STAFF REPORT

SUBJECT: H-2021-0030
 Popeye’s Drive-Through – CUP

LOCATION: The site is located at 6343 N. Linder Road, the southwest corner of W. Chinden Boulevard/Hwy. 20/26 and N. Linder Road, in the NE ¼ of the NE ¼ of Section 26, Township 4N., Range 1W.

A. Proposed Revised Site Plan (dated: 4/15/2021 6/07/2021) NOT APPROVED

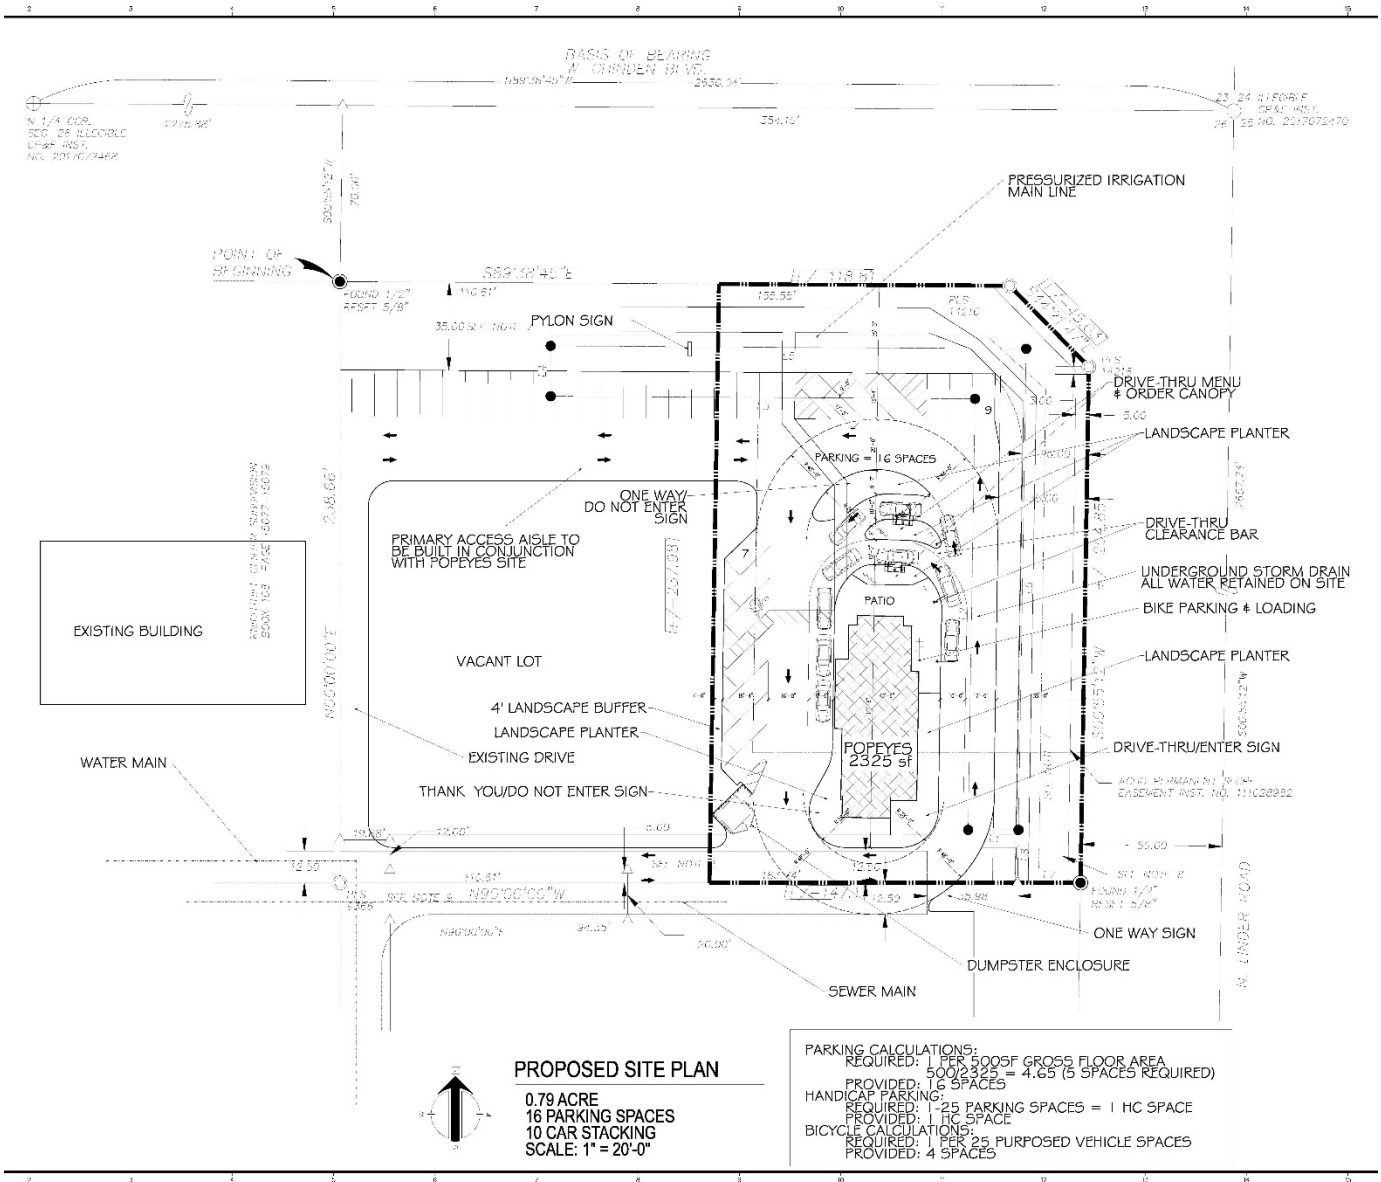
The proposed site layout places a dual ordering drive-through along the south of the site and the pick-up window on the east side of the building. With this site design the proposed drive-through has a minimal stacking lane due to the overall site and building being relatively small.

Furthermore, the site design is made for traffic to flow in a circular pattern around the building utilizing a portion of the drive aisle adjacent to the west side of the building as the stacking lane. Furthermore, the proposed site design with the anticipation of the extended north drive aisle as

the main entry point requires patrons who intend to park and utilize the dining room to go through the site along the west boundary, use the shared drive aisle along the south boundary to head east, and finally enter the site again to use the parking spaces. As proposed by the Applicant, Staff can envision patrons double stacking to order faster and block the one-way drive along the west boundary and effectively restricting patrons from using the parking spaces along the east boundary. Staff also envisions patrons blocking and/or utilizing the north drive aisle and obstructing both this anticipated exit and entry for the site with as few as seven (7) cars stacked along the west of the building (approximately 140' from the ordering window to the north drive aisle).

Therefore, Staff recommends multiple changes to the site design: 1) one drive-through instead of two should be utilized; 2) the ordering and pick-up areas be flipped on the site to have the pick-up window on the west side of the building and the menu boards located near the north/east side of the site; and 3) flip the parking from the east side of the site to the west side of the site. These changes will allow for adequate stacking with less potential of obstructing the existing drive aisle along the south boundary of the site and allow customers who want to utilize the dining room better access to parking which would be on the west side of the building instead of the east. Further analysis is below in the **Access and Parking** sections of this report.

Per the submitted site plan, the stacking lane(s) are along the west side of the site and are separated from the west drive aisle by striping despite having two drive-through menu boards/speakers. With two proposed drive-through speakers, Staff does not find the proposed separation to be sufficient. In fact, and as noted above, Staff believes patrons would utilize the drive west drive aisle as the second stacking lane and completely obstructing this drive aisle and site exit. Staff's recommended changes above would help alleviate this issue by removing the dual drive-through speaker and placing the singular one along the north/east side of the site adjacent to the one-way drive aisle that is eight feet wider than the west drive aisle. Further analysis is below in the Access section of this report.

Access: Access to the site is shown via two drive aisles: one along the south boundary which is currently existing, and; one abutting the site in the northwest corner that is proposed to be constructed with this project. The new proposed drive aisle would traverse an undeveloped lot and connect to a drive aisle that serves existing commercial buildings along Chinden (including an additional drive-through). This drive aisle is the proposed main entry point to the site, according to the Applicant.

First, Staff recommends the drive-through contain only one (1) ordering speaker to help mitigate double stacking issues. Secondly, Staff recommends mirroring the site to have the menu board on either the east or north sides of the site therefore moving the pick-up window to the west side of the building. Staff does not know if the entire site needs to be flipped placing the main entrance facing south; this would not be preferred as the more architectural elevations would be facing internal rather than towards the adjacent busy roads. However, Staff assumes the internal portions of the building can be flipped to move the pick-up window to the west side of the building and maintain the patio space and building entry facing north along the entryway corridor. With these changes, the entire building can be shifted south and remove the need for any vehicle use area along the south side of the building. Additional landscaping or other features could be utilized in this area. Furthermore, the building shift to the south allows for the menu board to be placed near the north side or northeast corner of the building further away from the patio area—Staff envisions there would be adequate room along the north of the building site to include additional landscaping to screen and mitigate the additional noise generated by vehicles ordering while patrons utilize the patio space.

Consistent with Staff recommendations above, Staff recommends flipping the parking from the east side of the site to the west side of the site and face them south to further mitigate conflicts of stacking and parking. By placing the angled parking on the west side and facing them south instead of north, combined with Staff's previous recommendations of flipping the order and pick-up areas, the building can be shifted east by approximately the width of the proposed 20' drive aisle and the angled parking stalls. Therefore, the east drive aisle and south entrance could be used solely for ordering and stacking at the new location of the menu boards along the north end of the site. With the angled parking along the west side of the building, the one-way drive aisle must be at least 13 feet wide per UDC 11-3C-4 but Staff feels it should largely mirror what is currently proposed on the east side (approximately 20 feet wide) to allow for the drive aisle to function as the escape plan as discussed above. Furthermore, the flip of the site allows the escape lane and the drive-thru exit to pick-up their order and immediately exit to the south without impeding as many parking spaces. The Applicant could then designate the parking along the north drive aisle as employee parking to meet the drive-through establishment specific use standard that states employee parking may be impeded by stacking lanes (the new order and stacking location along the east and north sides of the building could impede the parking along the north boundary).

Pedestrian Walkways: A striped pedestrian walkway is depicted on the site plan from the proposed building to the multi-use pathway along W. Chinden Blvd. as required by UDC 11-3A-19B.4a. It also appears there is a sidewalk proposed near the south boundary of the site as a connection to the sidewalk along Linder Rd. However, it is not clear by the submitted plans where the sidewalk is and appears to run into the proposed trash enclosure location. *Staff's recommended changes would allow the trash enclosure to be pushed further north enough to allow for an unobstructed sidewalk along the south boundary of the site. Because it is unclear if the Applicant is proposing a sidewalk along the south boundary, Staff recommends the Applicant make it clearly visible where the pedestrian facilities are when revising the site plan; this allows the Applicant to match what is existing along the south side of the drive aisle along the south boundary of the site. In addition, this pedestrian walkway to Linder has to traverse a drive aisle and should be distinguished from the driving surface. The Applicant should also make it clear where a pedestrian connection to the Linder sidewalk is*

Furthermore, subsection B of this code section requires that the pedestrian walkway be distinguished from the driving surface by being constructed with pavers, brick, or scored/colored concrete. The proposed site plan appears to only show striping which does not comply with this code section. The Applicant should show compliance with this code section with a future CZC submittal.

- b. The site shall be redesigned per the specific revisions noted below in VIII.A3 and A4 below.
 - c. The west drive-aisle shall be no less than ~~20~~ 15 feet in width (not including the drive-through lane) and the east drive aisle shall be no less than 12 feet in width.

- d. The parking spaces along the north boundary shall be ~~restricted to~~ shown as employee parking only on the revised site plan.
 - e. Additional signage is required throughout the site to efficiently and adequately direct patrons to the menu boards and throughout the site with minimal conflict.

3. The site plan submitted with the future Certificate of Zoning Compliance application shall be revised as follows:
 - a. ~~Depict the pick up window on the west side of the building and the menu board/order speaker along the north/northeast side of the building;~~

- b. ~~Depict the north facing angled parking to be on the west side of the site instead of the east side of the site and angle them southbound;~~
 - c. ~~Shift the proposed building to the east and to the south to allow for better utilization of the site along the north drive aisle with the option to incorporate more landscaping for screening;~~

- d. ~~Designate the parking along the north boundary of the site as employee only parking and move the handicap space to the new parking along the west boundary to place it closer to the building entrance;~~

- e. ~~Depict pedestrian facilities along the south boundary of the site to match what is on the south side of this shared drive aisle; depict these pedestrian walkways and their connections clearly on revised site plans;~~

- f. Per UDC 11-3A-19B.4b, depict pedestrian walkways across driving surfaces to be constructed with bricks, pavers, and/or colored or scored concrete to clearly delineate the driving surface from the pedestrian walkway.

B. Proposed Landscape Plan (dated: 4/15/2021) **NOT APPROVED**

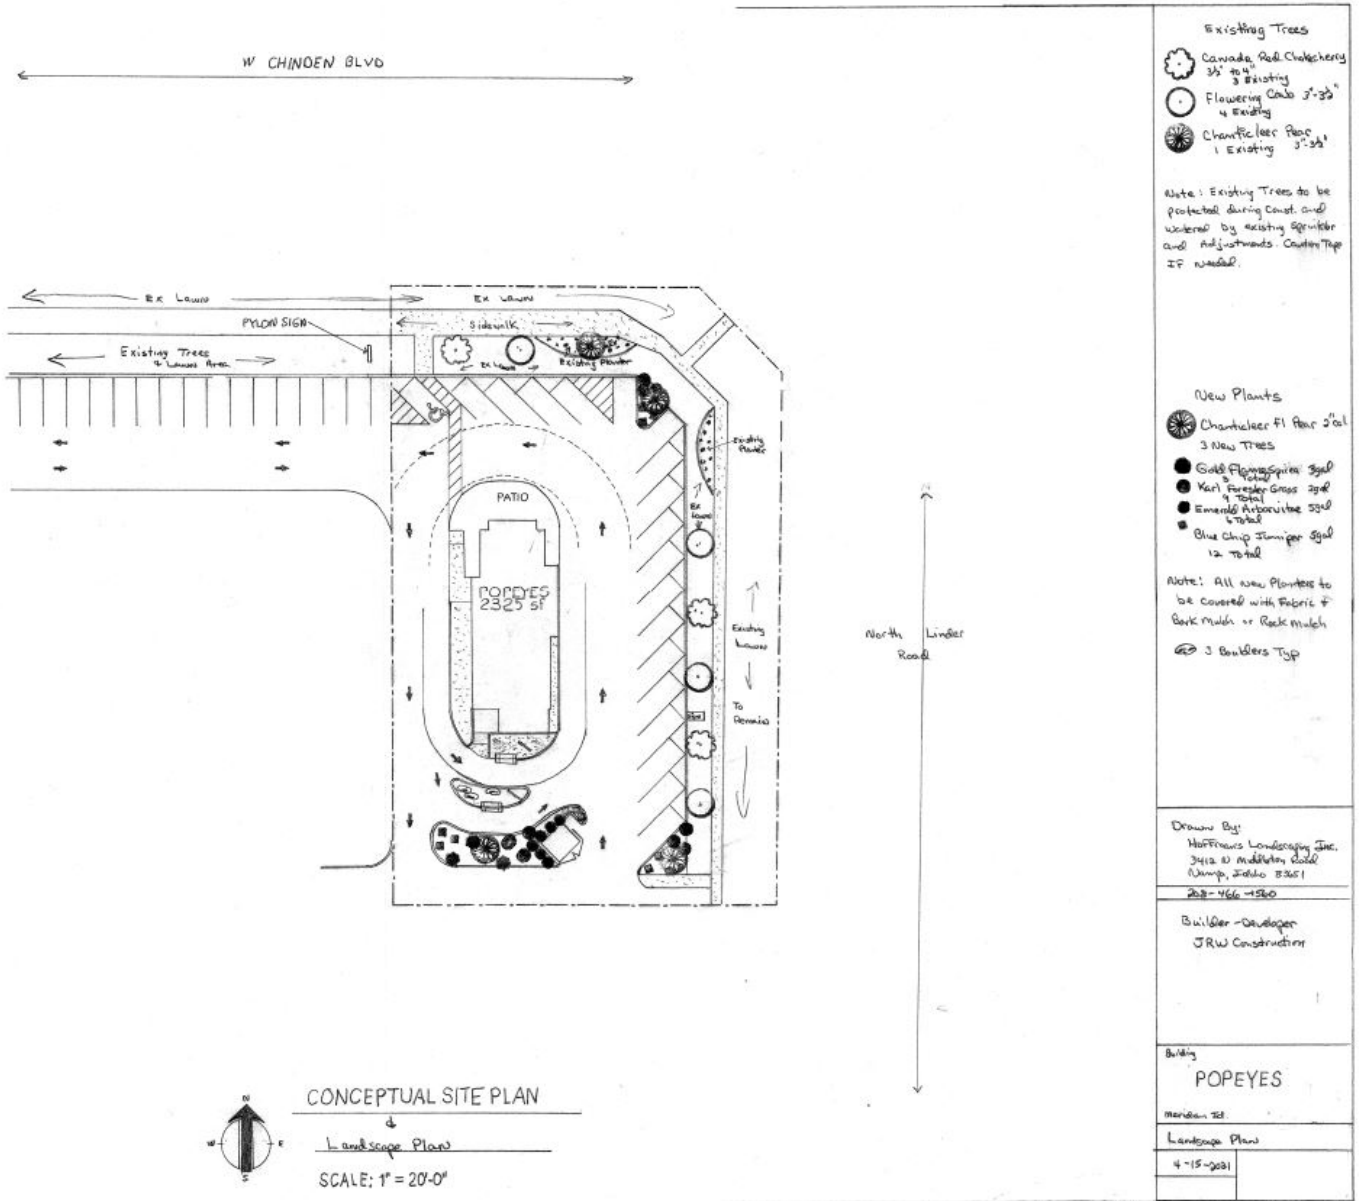
A minimum 5-foot wide landscape buffer is required to be provided along the perimeter of the parking or other vehicular use areas as set forth in UDC 11-3B-8C.1. *The proposed parking spaces align the perimeter of the site which allows the Applicant to utilize the existing street buffer landscaping as the required landscaping. Staff agrees with this design to maximize the site design. This code requirement is also applicable along the west boundary of the site where a 12-foot wide one-way drive is proposed heading south. The submitted plans do not show any perimeter landscaping along this boundary. Because the adjacent property is owned by the same property owner and the western drive aisle is intended to always function as a one-way drive aisle, Staff is amenable to placing the required 5-feet of landscaping on that property instead. **With the CZC submittal, the landscape plan should be revised to show the required 5-foot wide landscape buffer adjacent to the drive west drive aisle.***

4. The landscape plan submitted with the future Certificate of Zoning Compliance application shall be revised as follows:
 - a. Show compliance with UDC 11-3B-8C by constructing the required 5 feet of perimeter landscaping along the west boundary adjacent to the revised angled parking location; this shall be constructed with this application regardless of the property line location because there is common ownership between the two properties.
